PROJECT NAME: FIGUEROA ROCIO PEREZ NEW SFR

PROJECT NUMBER: 2025100005

APPLICATION: DRC WAIVER REQUEST #33478

DEVELOPMENT REVIEW COMMITTEE WAIVER REQUEST

SFR Site Plan

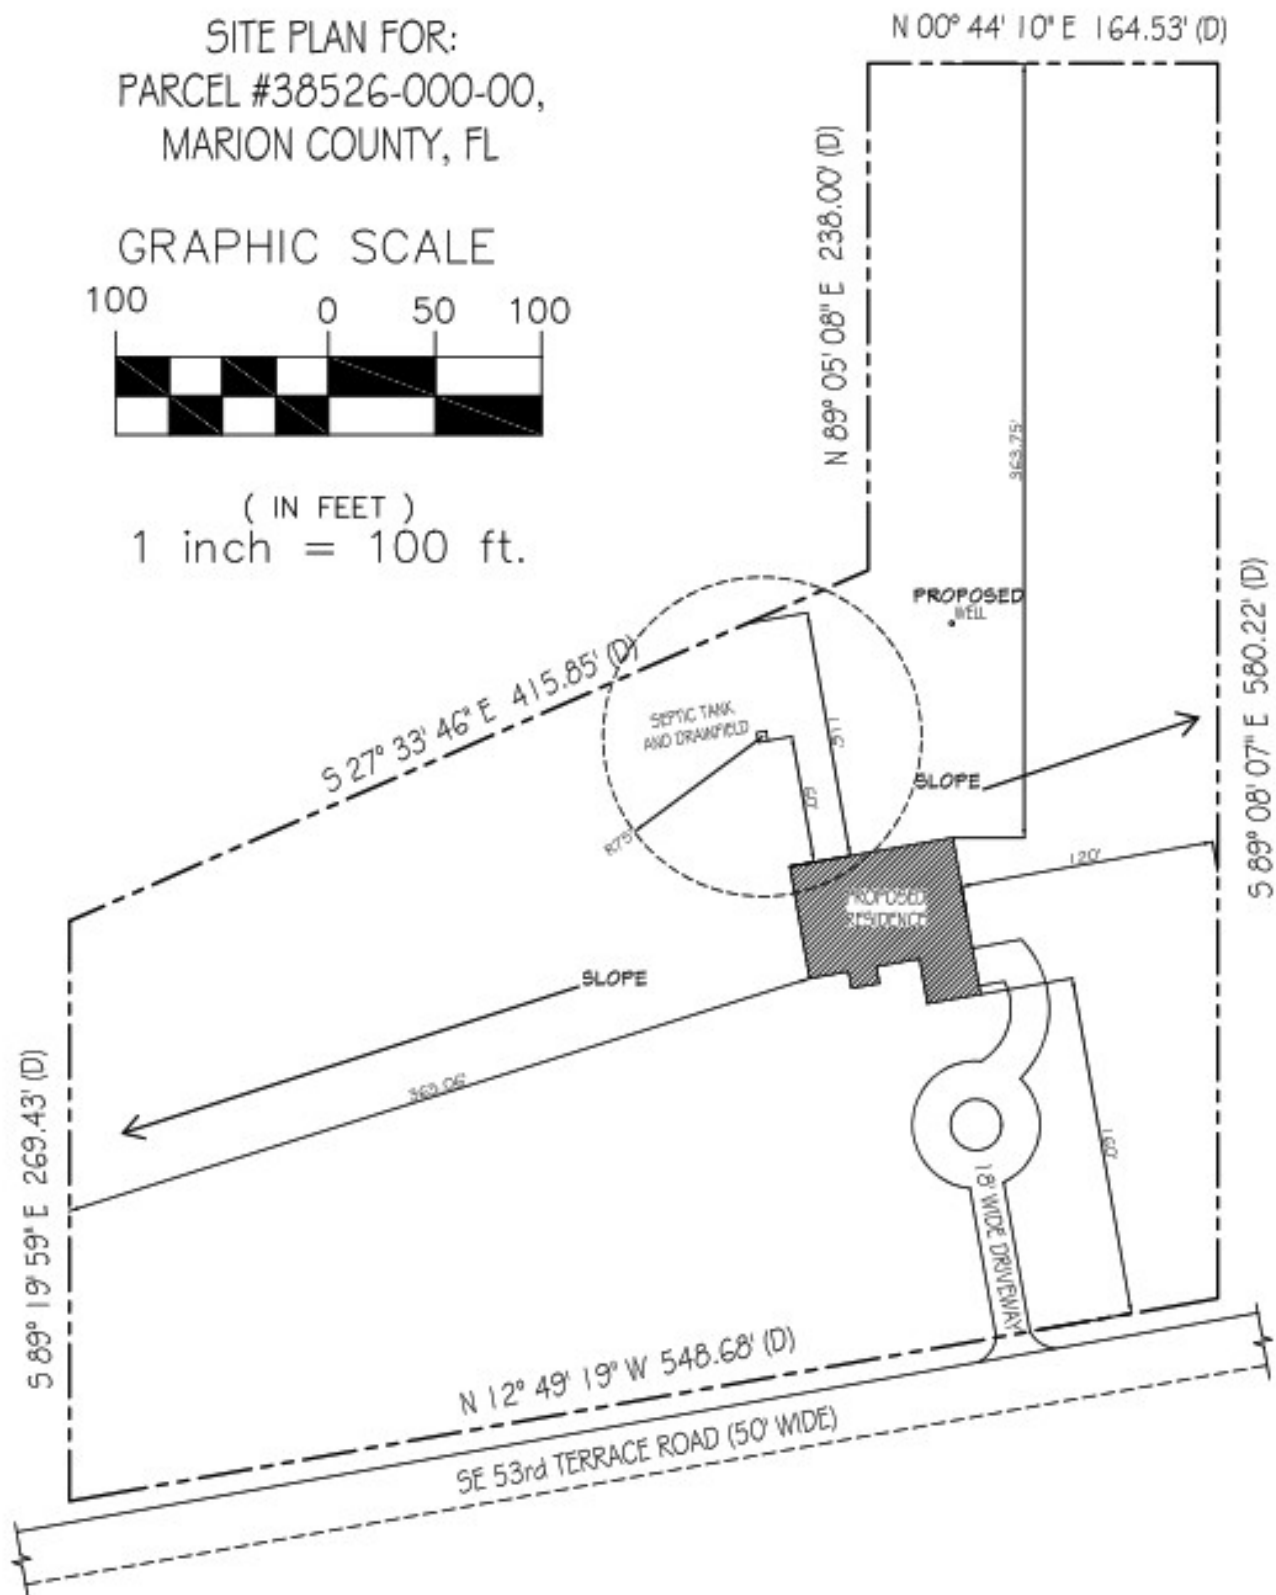
- 6 DEPARTMENT: ZONE - ZONING DEPARTMENT
REVIEW ITEM: 6.14.3.B - Onsite Waste Treatment and Disposal Systems (OSTDS)
STATUS OF REVIEW: INFO
REMARKS: If approved, septic system shall be at least 5' from property lines.

- 13 DEPARTMENT: DOH - ENVIRONMENTAL HEALTH
REVIEW ITEM: LDC 6.14.2.B(2) - Connection requirements
STATUS OF REVIEW: INFO
REMARKS: Defer to Marion County Utilities for connection requirements.
If installing a well a permit will be needed through the Department of Health in Marion County.
Please change the site plan to reflect the 75' radius around the well instead of the septic system.
